PLAN COMMISSION REPORT

Proposal: Cooperative Boundary Agreement Review

Description: Review a building, site, and operation plan for the construction and utilization of a ±53,000 square-foot commercial building located at 3030 CTH K to ensure compliance with the Cooperative Boundary Agreement between the Village of Raymond and the Village of Caledonia.

TO: Village of Raymond Plan Commission
CC: Barbara Hill, Jeff Muenkel, Kari Morgan, Mark Molinero
FROM: Ben Kohout, AICP, Planning Consultant
RPT DATE: February 18, 2025
MTG DATE: February 24, 2025
APRVL DATE: February 24, 2025
RE: Milwaukee Powersports, Inc. –Conditional Use Permit & Site Plan Plan Operations
(SPPO) Review, Soils Disturbance Request (Greater than one acre)

2 OPTION C.2 - SITE PLAN
PS-C.2.2 1" = 60'-0"

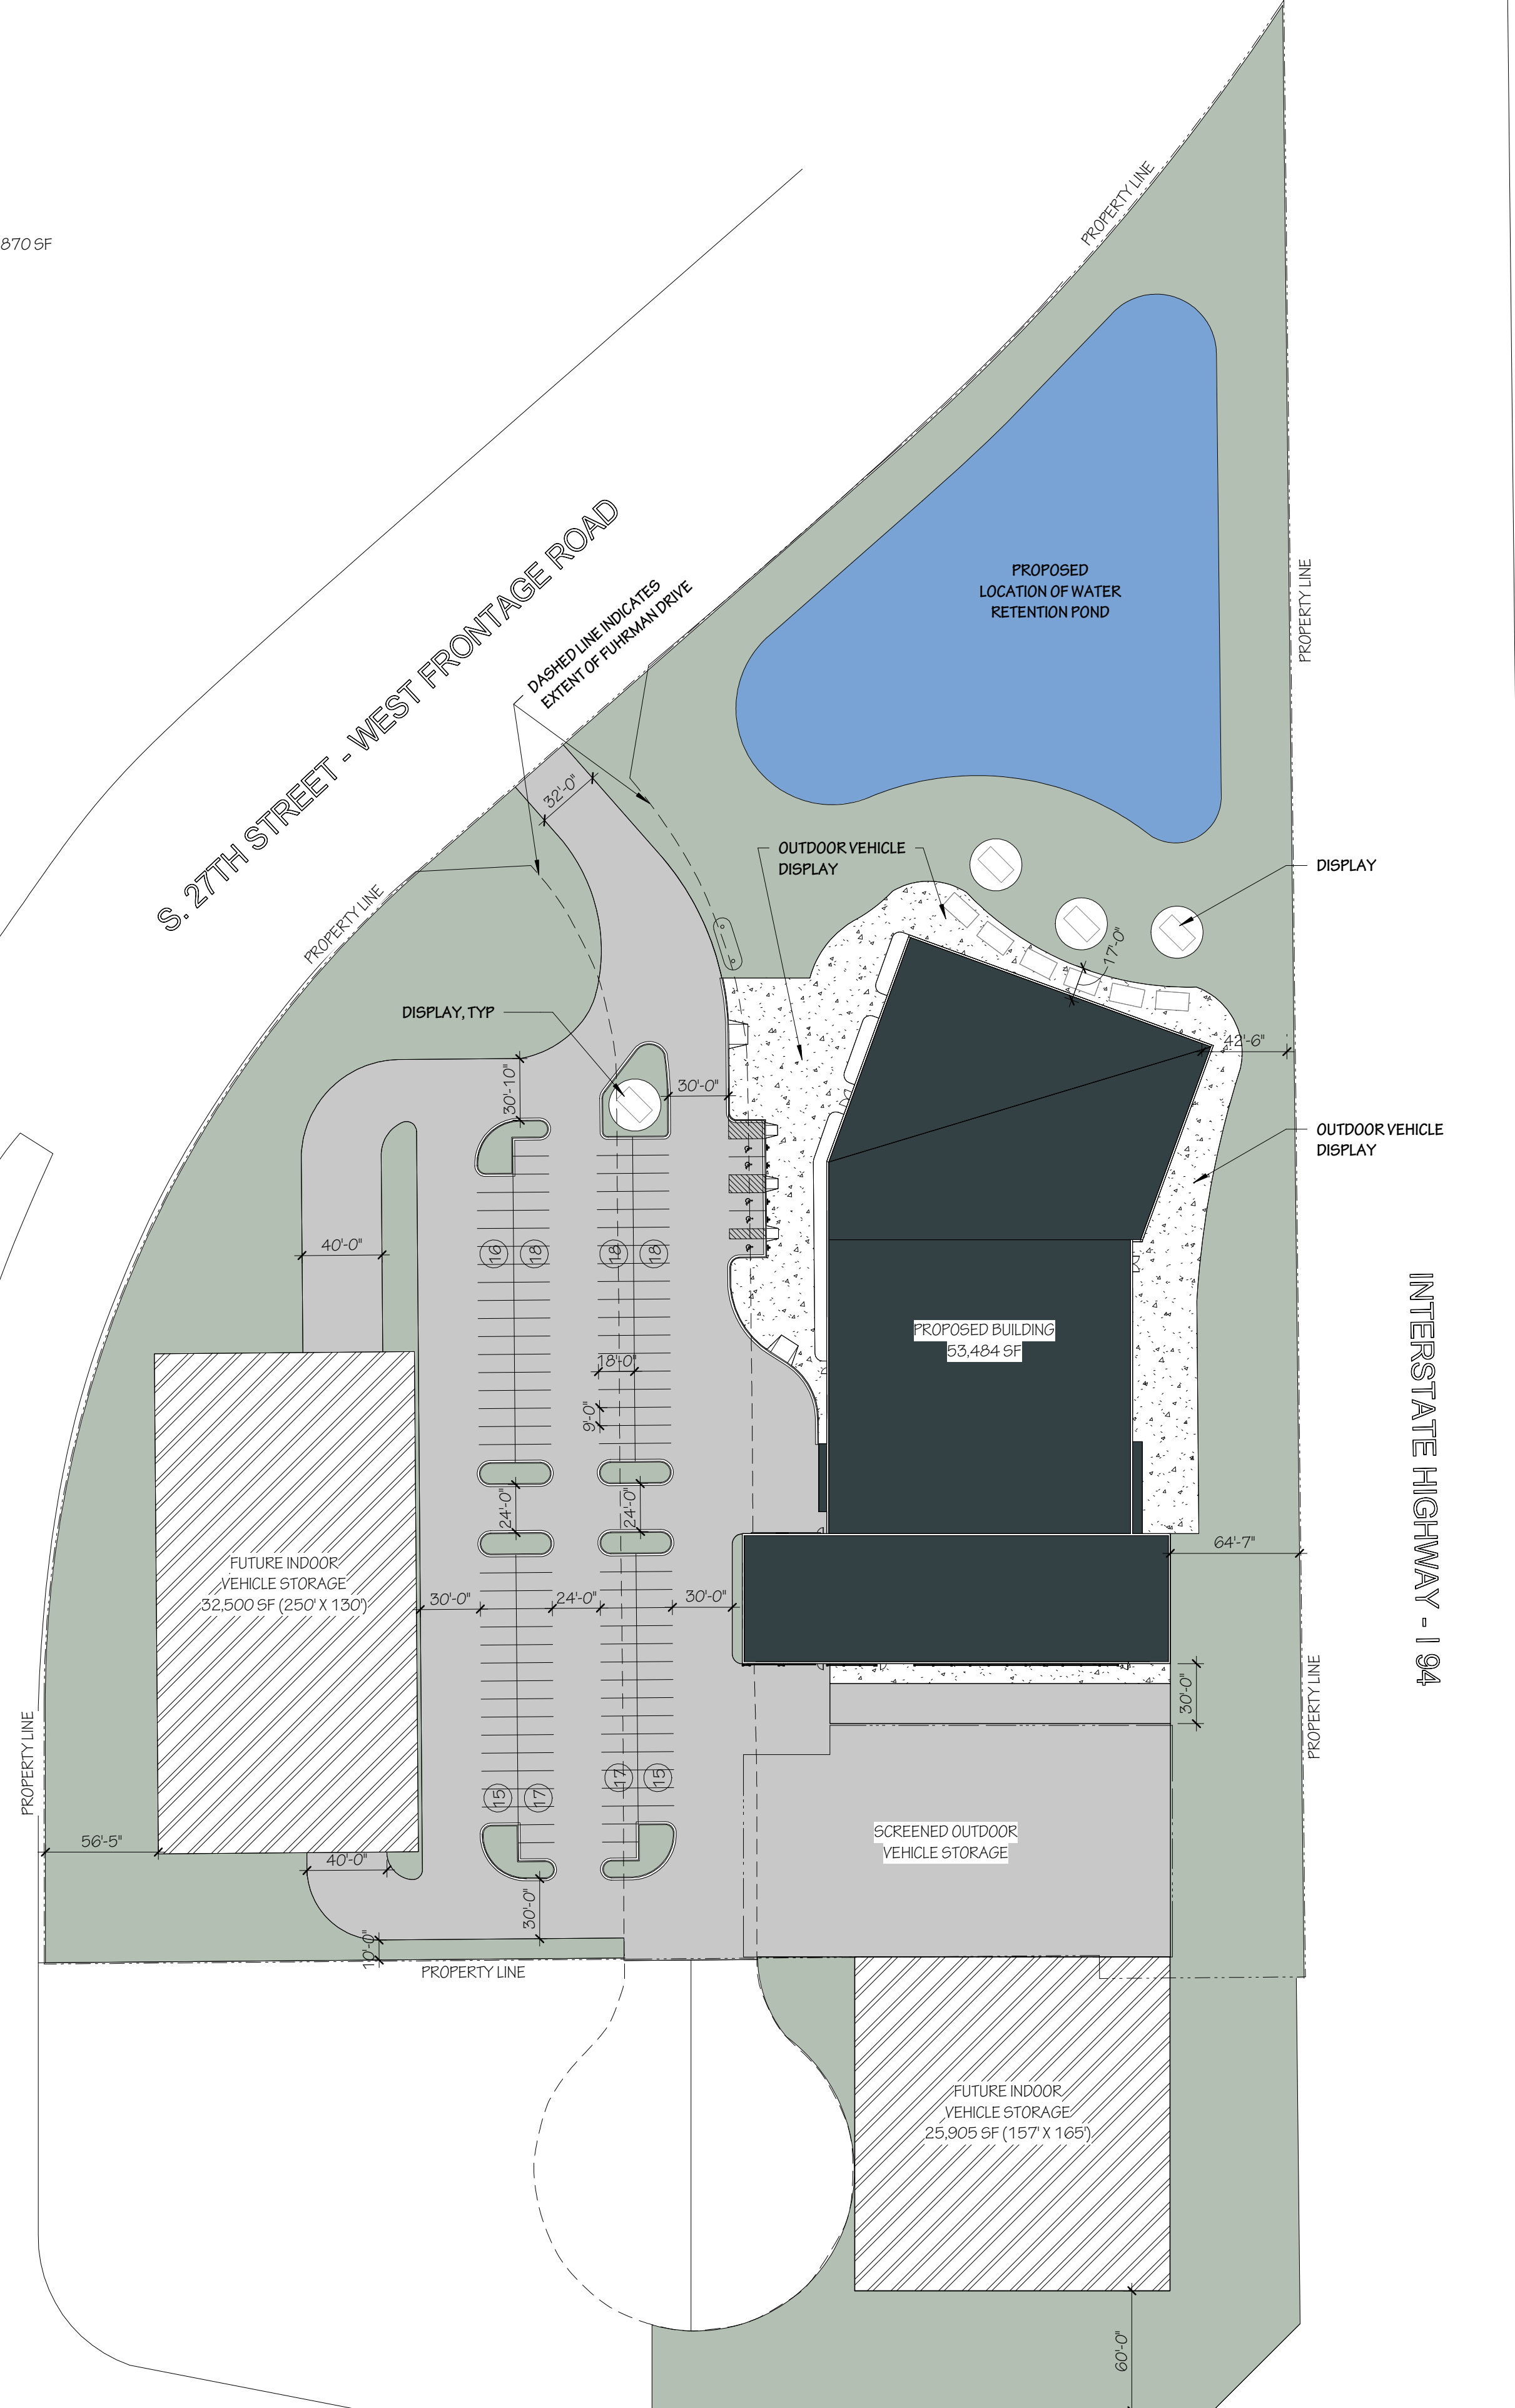
Regarding surfacing, the proposed outside storage and display area is planned to be large stone gravel, which may not meet the surface requirements called out in Section 25-12-1 (g). The Plan Commission will want to determine if they are okay with the proposal of gravel in light of this:

- k. **Refuse Disposal:** A dumpster enclosure is not defined on the submitted plans.

Section 25-4-1 (c) (3) (d)(15) calls out a need to screen any dumpster enclosure areas, and to provide for a dumpster enclosure area.

- c. Outside dumpster area shall be called out on the site plan, with appropriate screening of said dumpster area, with closeable gates providing a four-sided visual screening effect. Said addition including either densely planted evergreens, shrubs, or opaque fencing at least 7 feet high shall be shown on an amended plan and presented to the Village Zoning administrator for review. Should there be questions on said plans, following review and determination by the Zoning administrator said plans may be inadequate to achieve screening, resubmittal to the Commission and Village Board for review and approval may be reserved by the Zoning administrator.

MILWAUKEE POWERSPORTS SITE LIGHTING PLAN FOR CEDAR CREEK MOTORSPORTS VILLAGE OF RAYMOND, RACINE COUNTY, STATE OF WISCONSIN

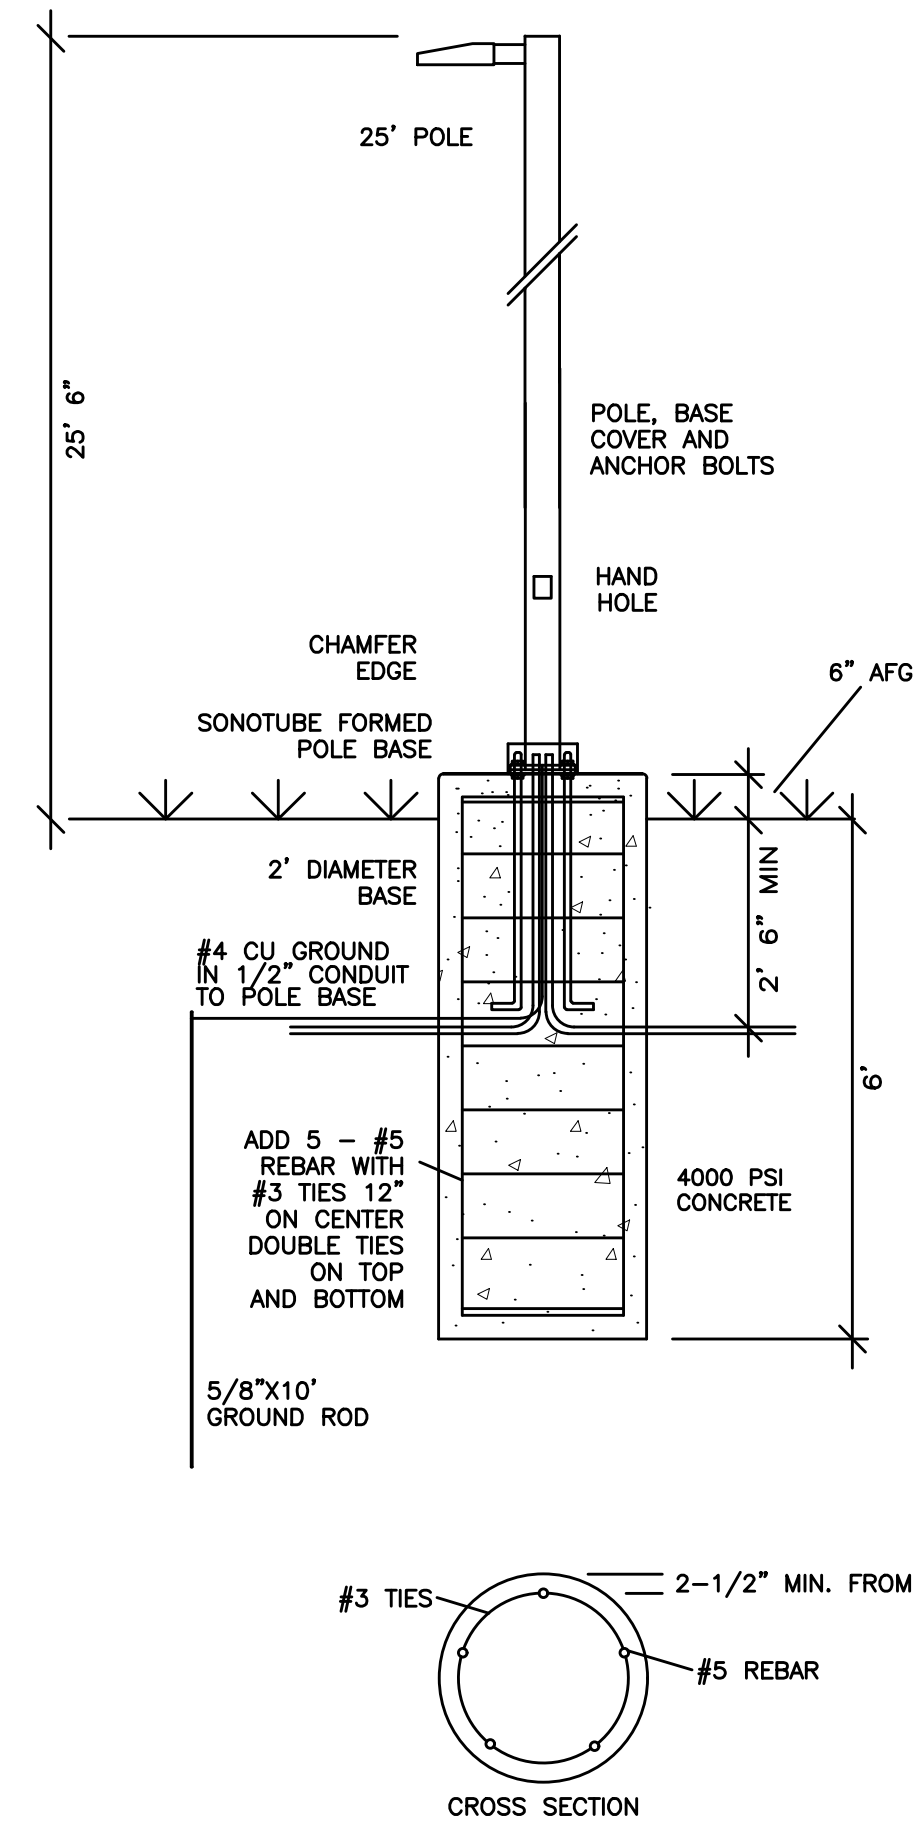
Exhibit K states that any light poles installed on a property should not exceed 15'-20' in height. The applicant is proposing 30' tall light poles. To comply with the guidelines, the applicant should modify the lighting plan to reduce the light pole height.

- g. **Exterior Lighting:** Section 25-7-16 addresses lighting standards for the Village. The applicant has provided a photometric plan for the proposed lighting. The lighting plans shows a range of 0.0-0.3 footcandles at the property lines. Generally 0.5 foot candles is considered appropriate at adjoining property lines. This standard is met.

The proposed light poles are not to 30 feet above ground level for parking lots with more than 20 spaces. This pole height was not clearly identified on the submitted plans and is a condition of approval.

5. Operator shall provide the following plans or plan updates for staff approval prior to receiving a zoning permit:
 - a. Lighting Plan including cut-sheets depicting full cut-off fixtures, mounting heights, pole heights at 30 feet or less for the fixtures around the perimeter of the property;
